ARES_R06_Power

-	UNIT	mm	SCALE	N/S	TITLE	ARES_R06_Power	
DWG.	DESIGNED	CHECKED	APPROVED	SUBJECT		00.ChangeLog.SchDoc	
-	212115				SUBJECT	00.ChangeLog.SchDoc	
Related DWG. No.		DWG. No.	Ver.			0	
HIGEN			V0.21			5

-	UNIT	mm	SCALE	N/S	TITLE	ARES_R06_Power		
DWG.	DESIGNED	CHECKED		APPROVED	SUBJECT	01.Connector.SchDoc		
-	212115				DWG. No.	Related DWG. No.

Control Power connector

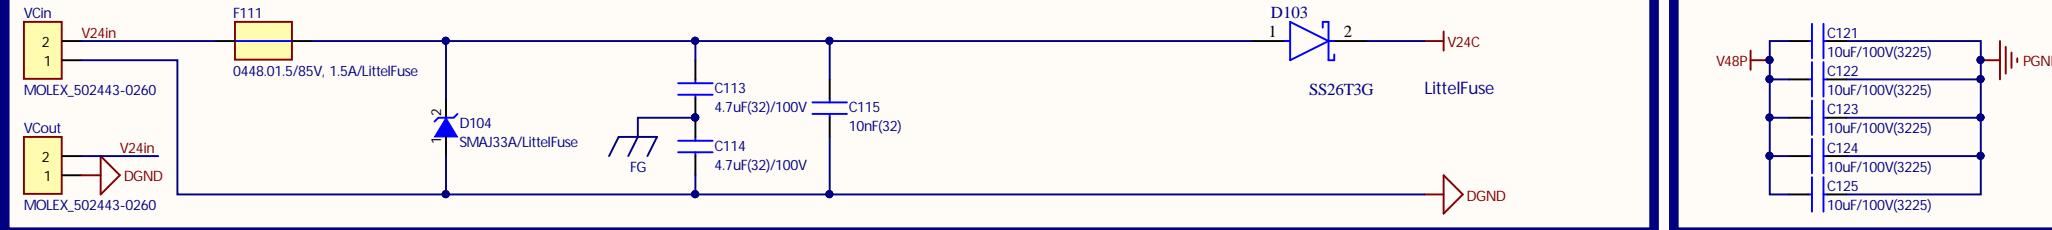
V0.10_01p_08_Safety board 용 전원 절파 추가(V24S_Ba)

V0.10_01p_08_FUSE 변경(0448.015)

V0.20_01p_01 C121,122,123,124 변경 및 추가

입력 커넥터 부터 회로 순서대로 부품 배치 할 것.

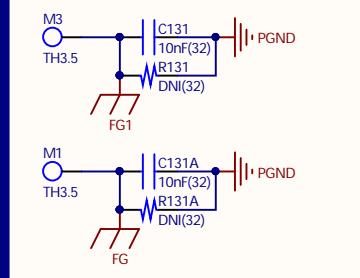
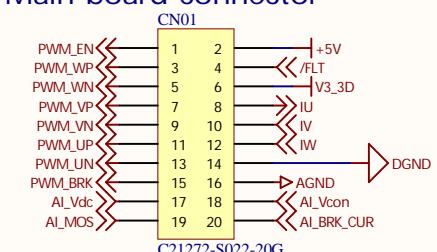
V0.10_01p_01_connector변경(53253-0270/Molex)

V0.22_01p_01_connector변경(DF1R-2P-2.5DSA/HRS)

BrakeV0.10_01p_03_FG 회로 변경
V0.10_01p_07_bolt 틀 2개 삭제**FG****Main board connector**

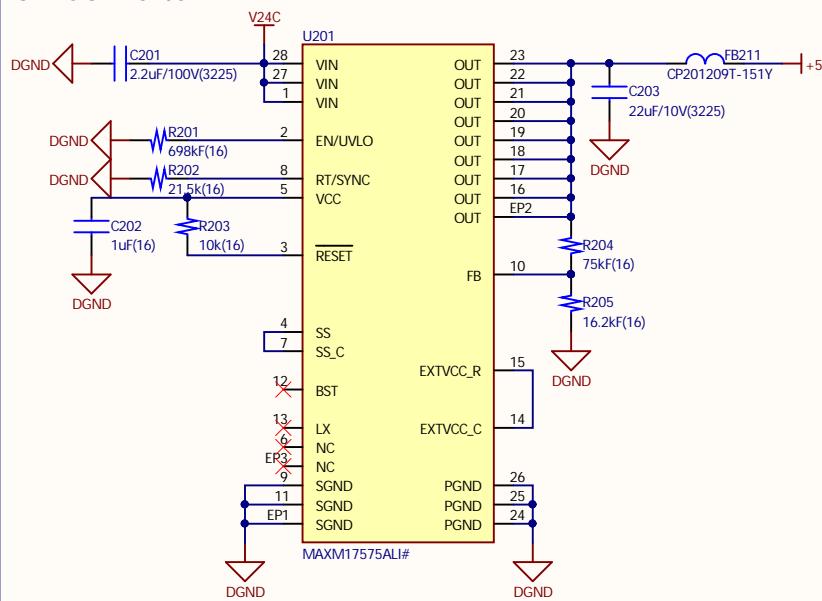
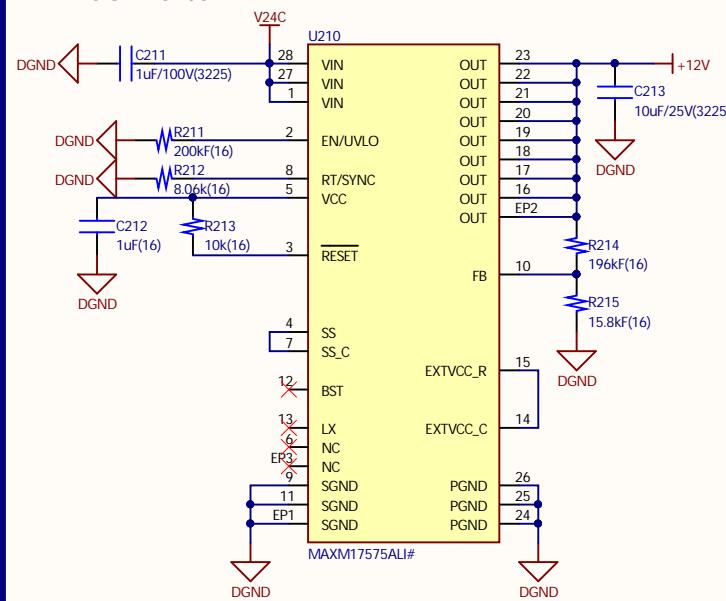
V0.10_02p_01_converter 파트 변경(MAXM17575)
V0.10_02p_02_converter 주변 회로 변경

V0.20_02p_03_FB211 추가(lib_3216)

V0.10_02p_03_NET 변경
V0.21_02p_01_NET 원복
V0.22_02p_01_U220 삭제

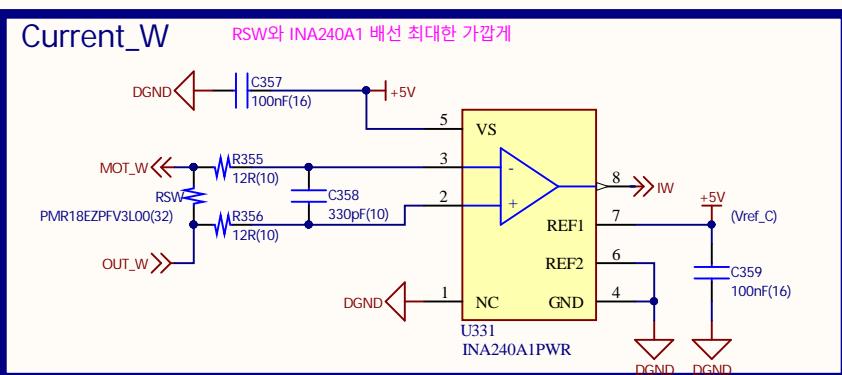
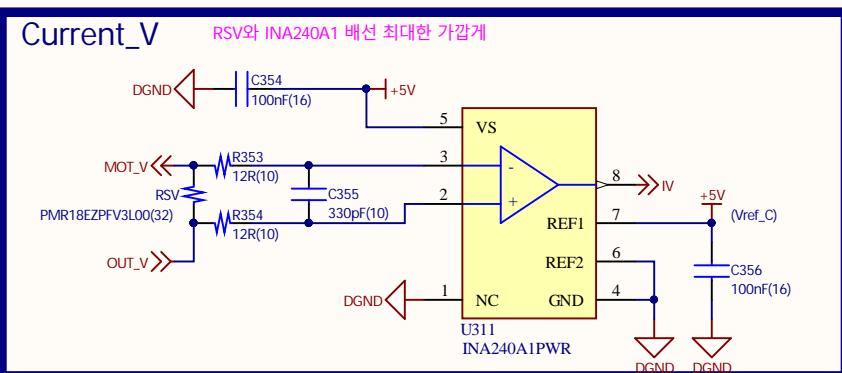
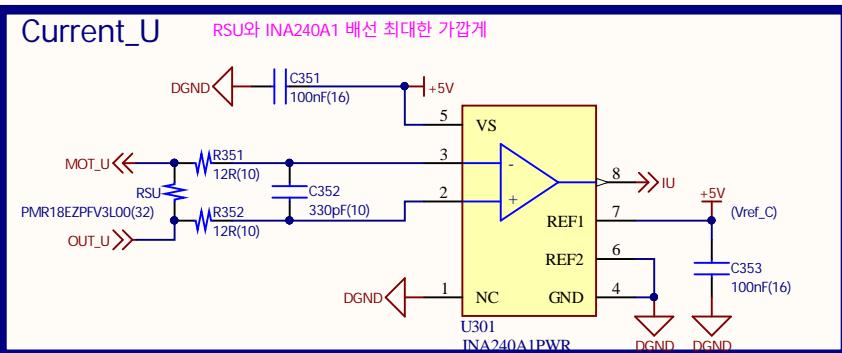
V0.20_03p_01_Sigma Delta#1,2 NET 변경
V0.21_03p_01_Sigma Delta#1,2 NET 원복
V0.22_03p_01 전류센서 변경(U301, 311, 331)
V0.23_03p Power Vref_C = +5V
V0.23_03p_Power U341(Vref_C) 삭제

V0.22_03P_01_INA240 Vref 전압 생성 회로 추가

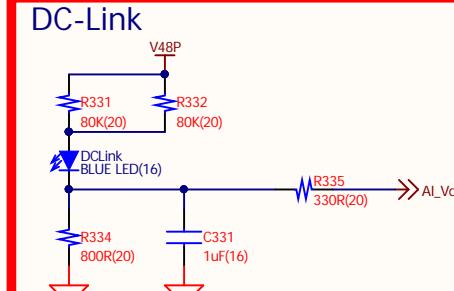
메인보드에 가리지 않는 영역 배치 잘보이는곳

V0.22_03p_01_LED변경 RED->BLUE LED(DCLink LED)

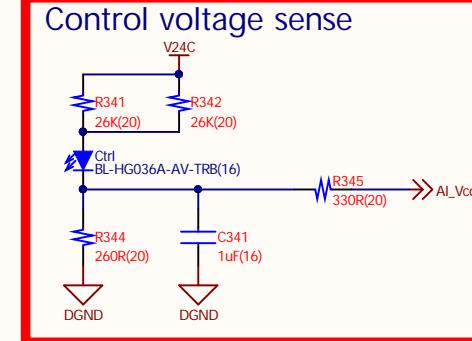
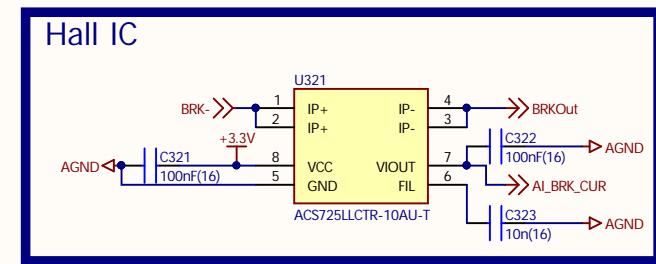
메인보드에 가리지 않는 영역 배치 잘보이는곳

V0.22_03p_01_LED변경 RED->BLUE LED(DCLink LED)
V0.24_03P_01_R333, 343 제거 -> SIZE & 값 변경
C332, 342 제거, C331, 341, R335, 345 값변경
GND 변경(PGND->DGND)
R334, 344 SIZE & 값 변경
